PUR-1378
ADDENDUM NO. 2
INVITATION TO BID

THE MARYLAND THEATRE EXPANSION
IN HAGERSOWN, MARYLAND

DATE: Monday, March 26, 2018

01 CW ELEVATION- CW01
1/2" = 1'-0"

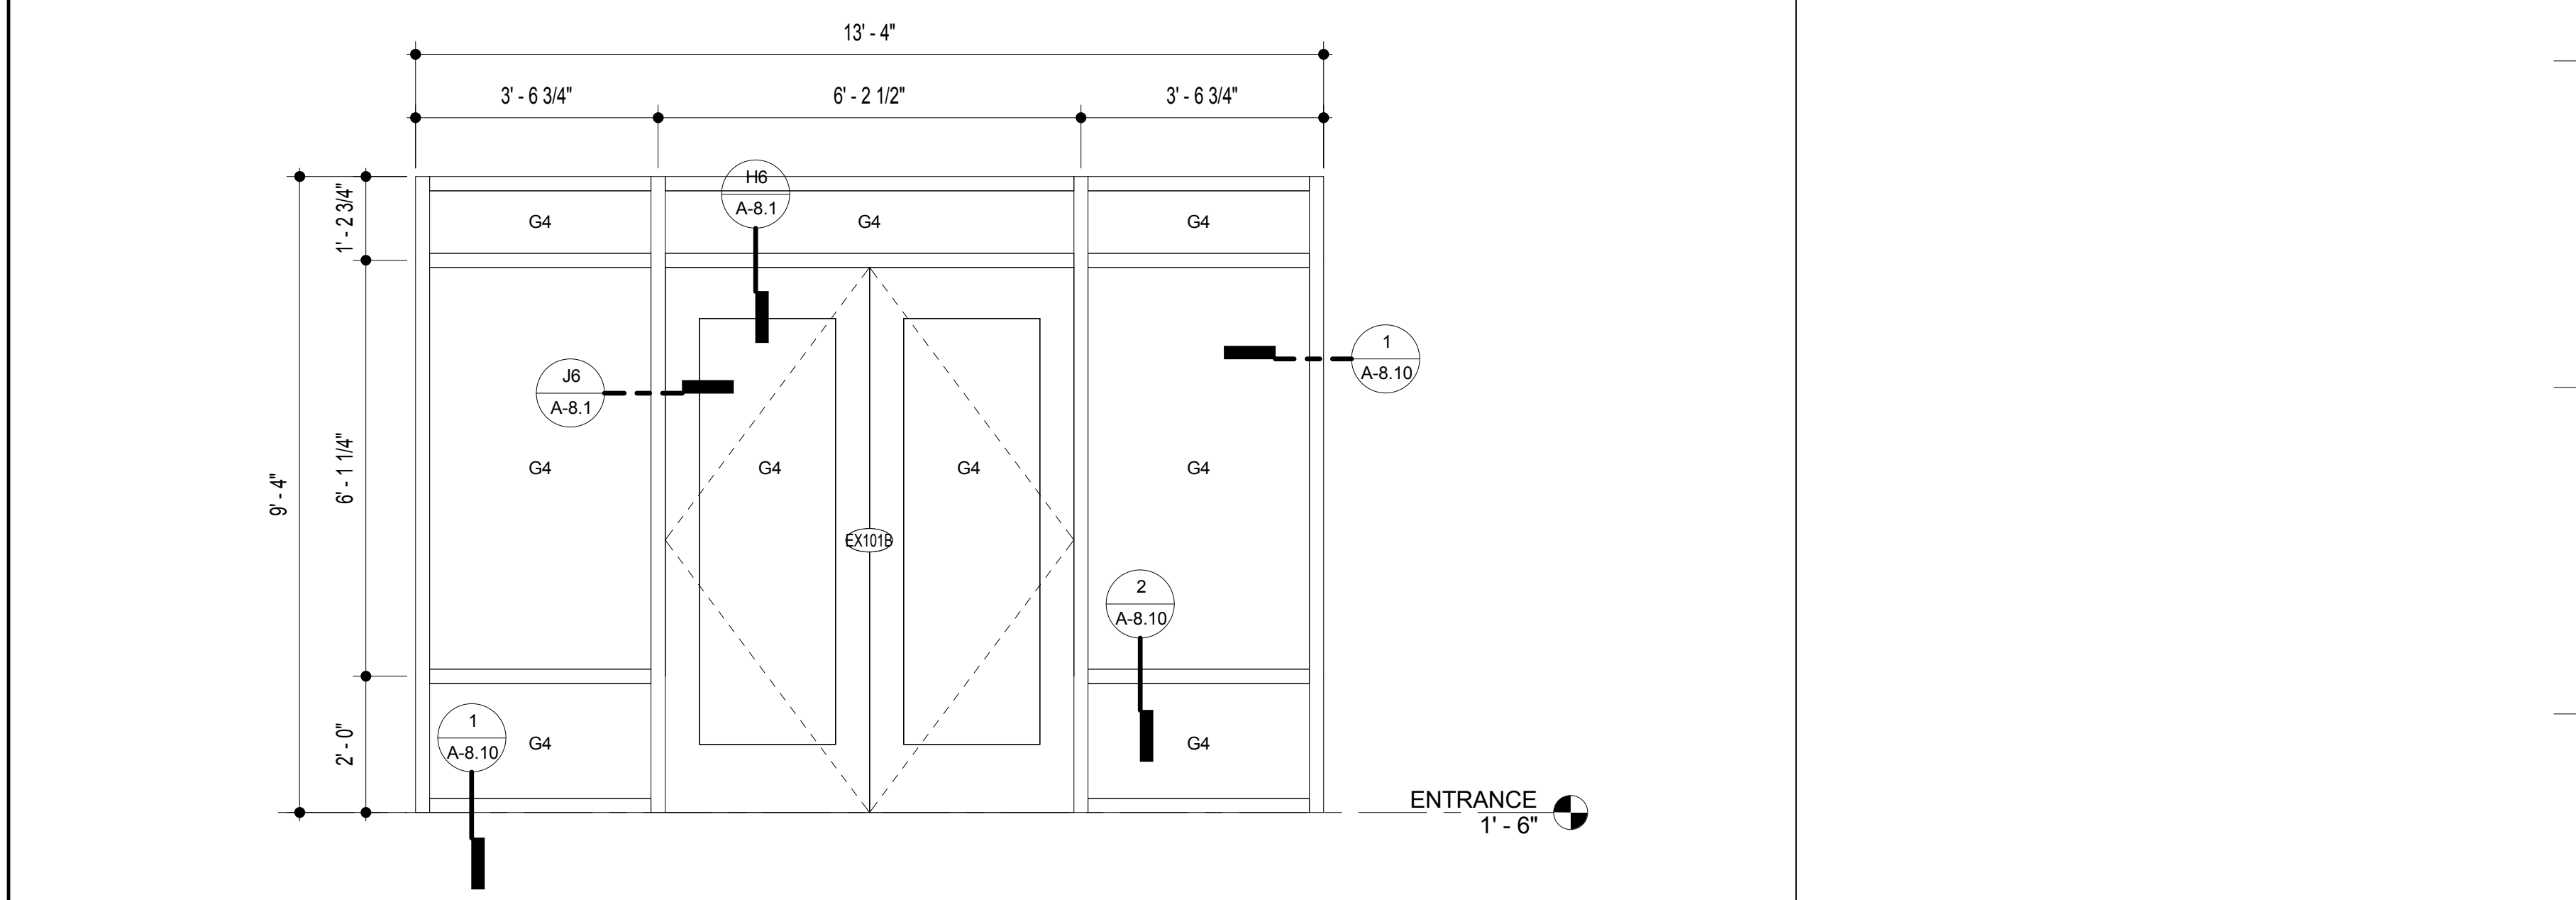
- REVISE** Revise door EX100 elevation to match sidewalk. Center Door in facade and replace sidelights with Metal Panels “MP” on sides.
- ITEM NO. 103** SHEET A-8.10– STAIR 1 PLANS AND SECTIONS *(SHEET ATTACHED)*

6A EXSF CORNER MULLION
3" = 1'-0"

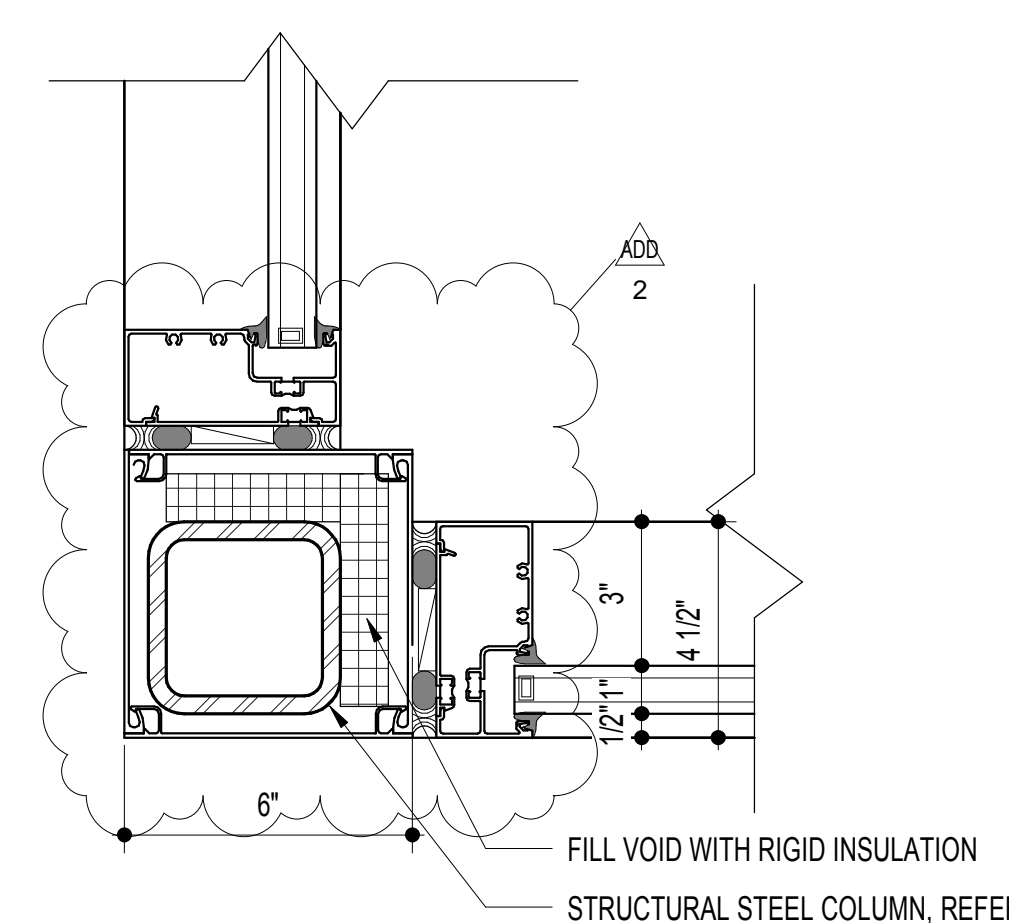
- REVISE** Revise SF Mullion Detail 6A
- ITEM NO. 105** SHEET M-2.1 – BASEMENT FLOOR PLAN – MECHANICAL *(SHEET ATTACHED)*
- REVISE** O/A intake ductwork serving electrical room. Ductwork to be re-routed through laundry room. See attached revised sheet M-2.1

8 2" x 6" EXSF SILL DETAIL WITH LEADED GLASS
3" = 1'-0"

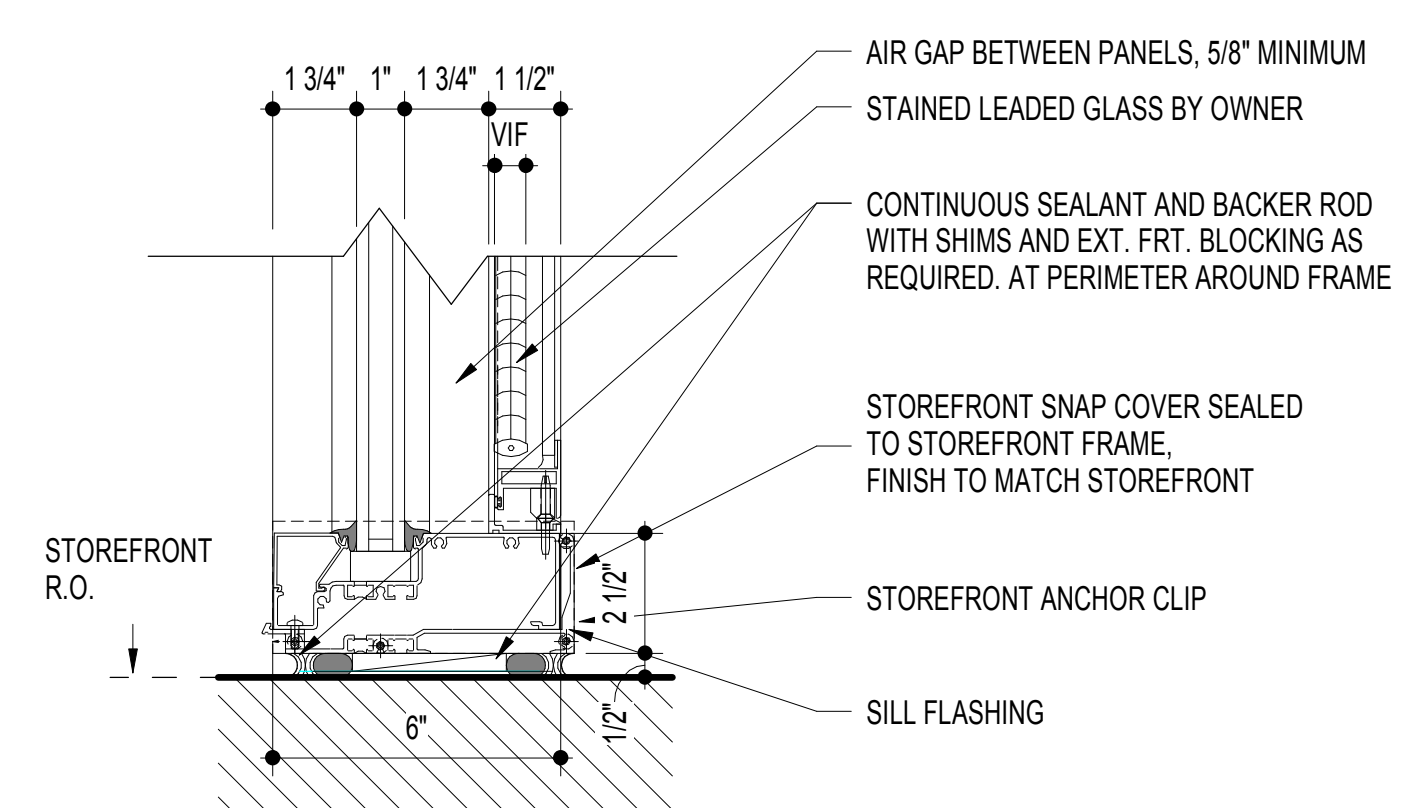
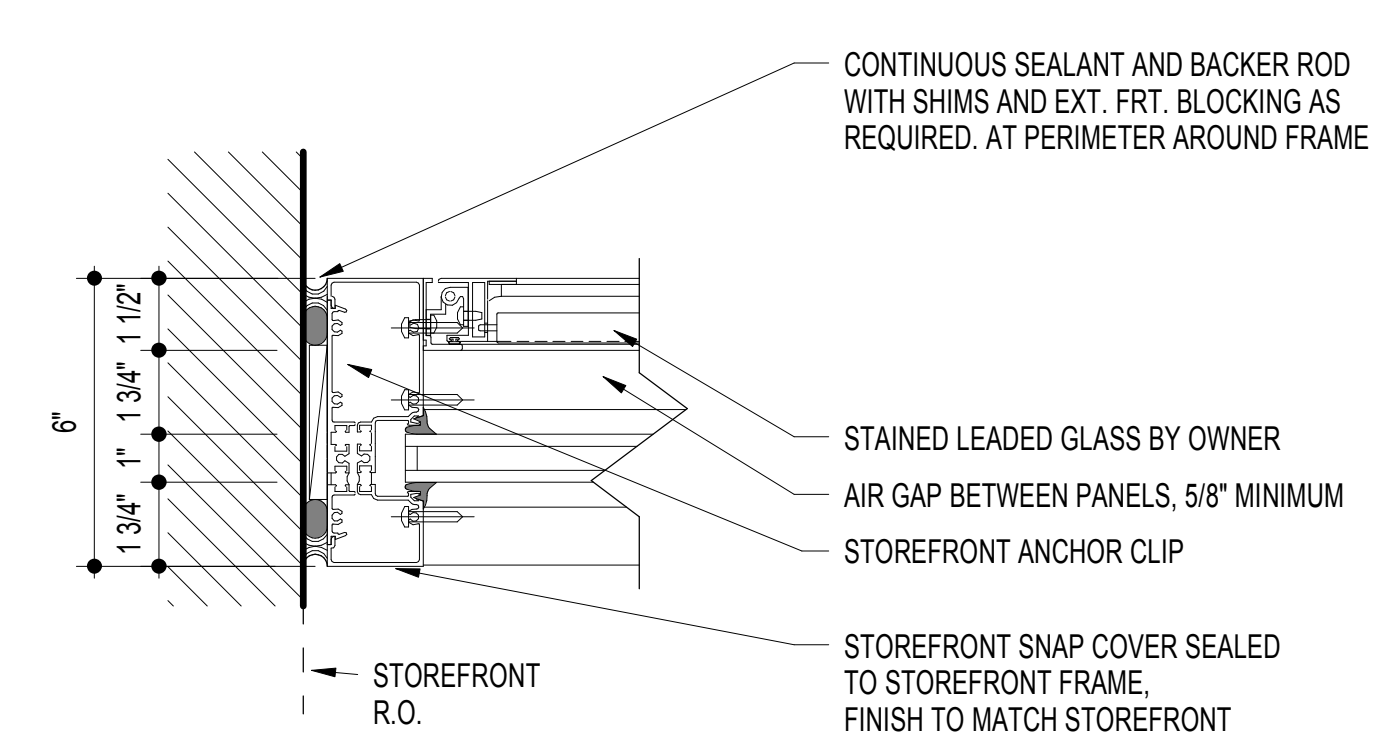
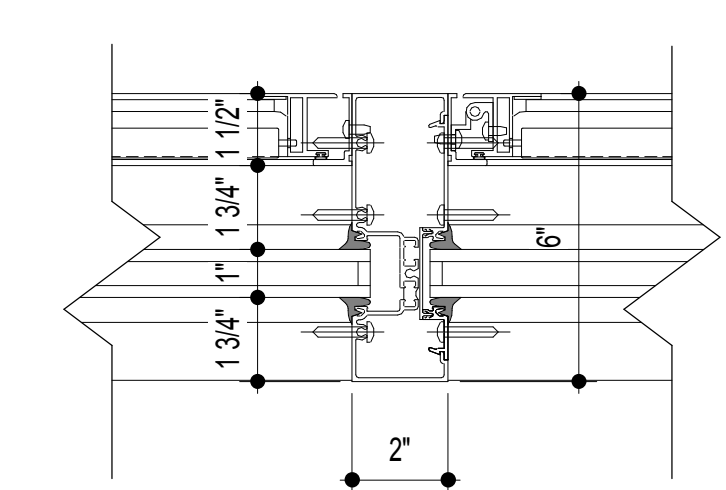
ITEM NO. 76: *Inquiry:* Reference detail 8 on sheet A-8.10; please clarify the use of 'snap cover'; where it is shown is going to interfere with the sill flashing required for the system. Detail 9 and 12 is noted to have it on the exterior of the frame?

ITEM NO. 89: *Inquiry:* Please clarify the frame material for the stained glass at frame type EX03 (Details 9-12 / A8.10)? I understand it is re-using existing stained glass, but there is no description what that “frame” is around the glass to hold it.

Response: This is a part of the storefront system. See spec section 08 43 13 - 2.2 B - it is the sill sash.

E-5.1
2/15/18
BID SET

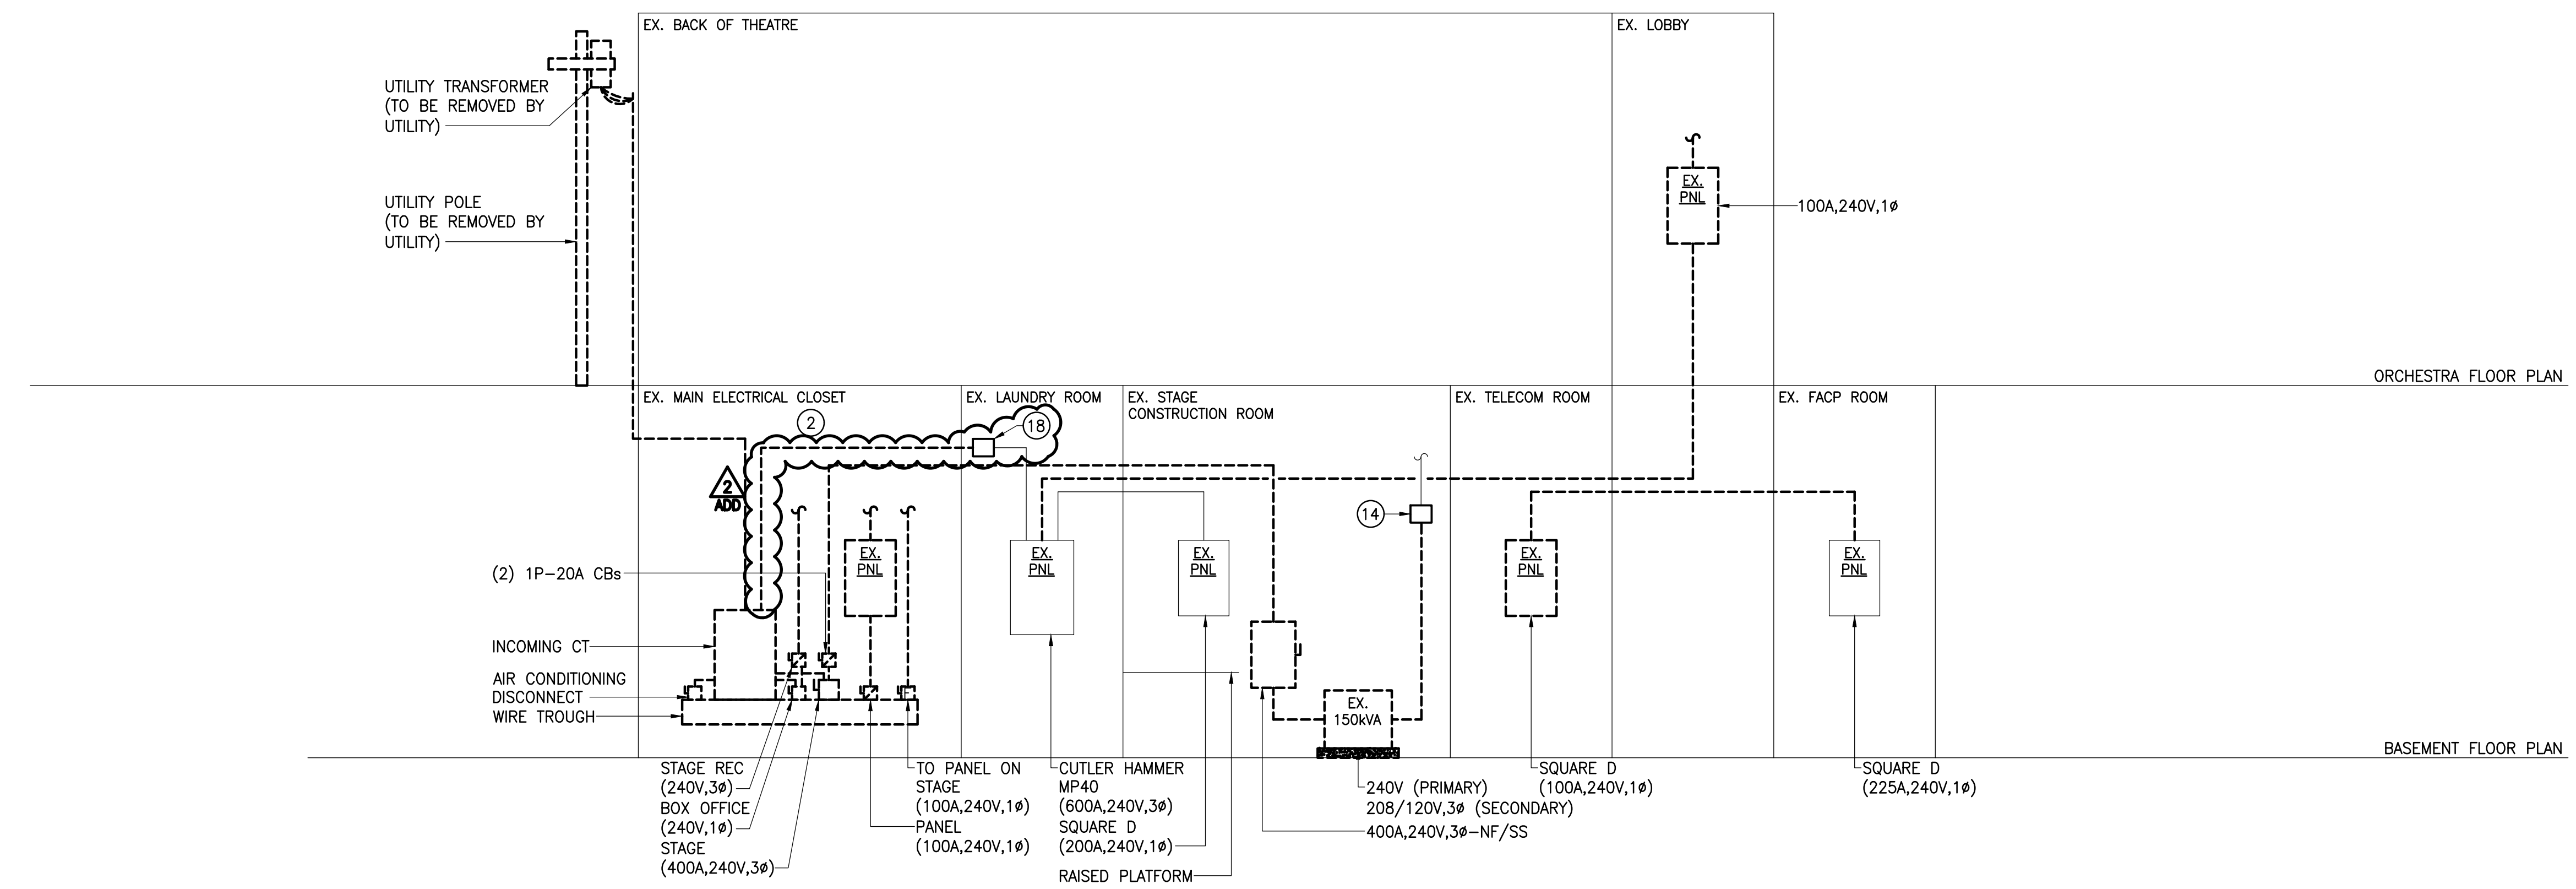
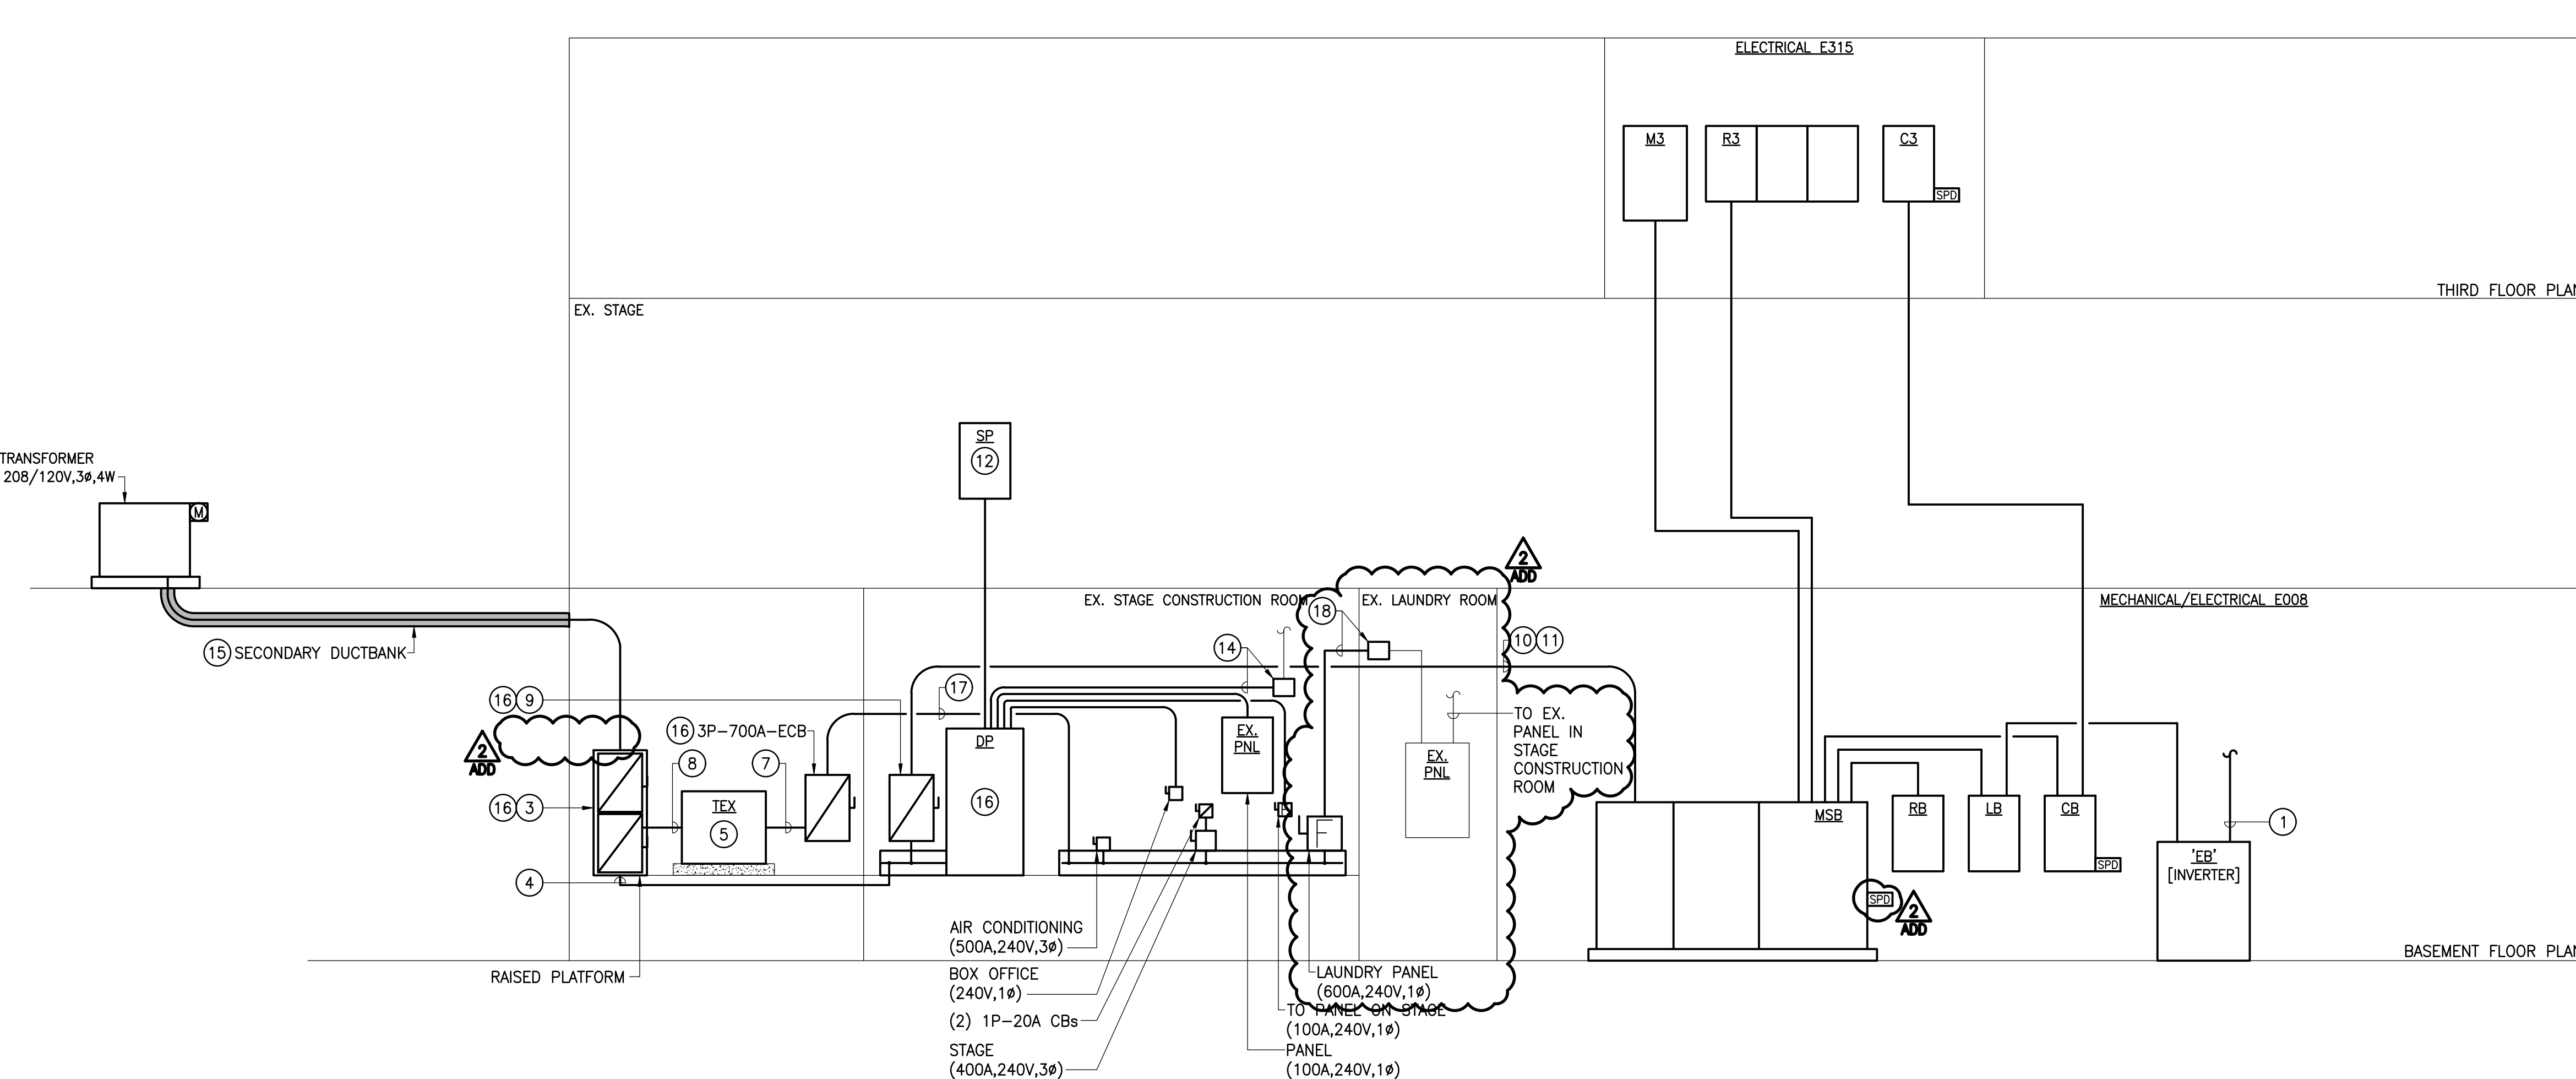
- REVISE** Riser Diagram per E-5.1.
- ADD** Surge Protection Device (SPD) to MSB.

- REVISE** Drawing Note #15 to read: “6 sets...”
- ADD** Drawing Note #18 to read: “intercept feed to Laundry Room panelboard and extend to disconnect at wire trough via 2 sets (3) 350kcmil + #1GW – 2-1/2”C.
- ITEM NO. 107** SHEET E-7.1 – PANELBOARD SCHEDULES – (DRAWING NOT ATTACHED)
- REVISE** MSB rating from 1200A to 1600A (100% Rated) LSIG MCB.
- ITEM NO. 108:** *Inquiry:* Can you please confirm the correct name for the obligee on the bid bond. There are a few variations in the specs including The Maryland Theatre in Hagerstown Maryland (pg 17 of 904); The Maryland Theatre Association (pg. 57 and 66 of 904); The Maryland Theatre (pg. 13 of 904) etc.
- Response:* The Maryland Theatre Association, Incorporated is the correct name.
- ITEM NO. 109:** Further information and clarification will be provided subsequently in a forthcoming Addendum No. 3.
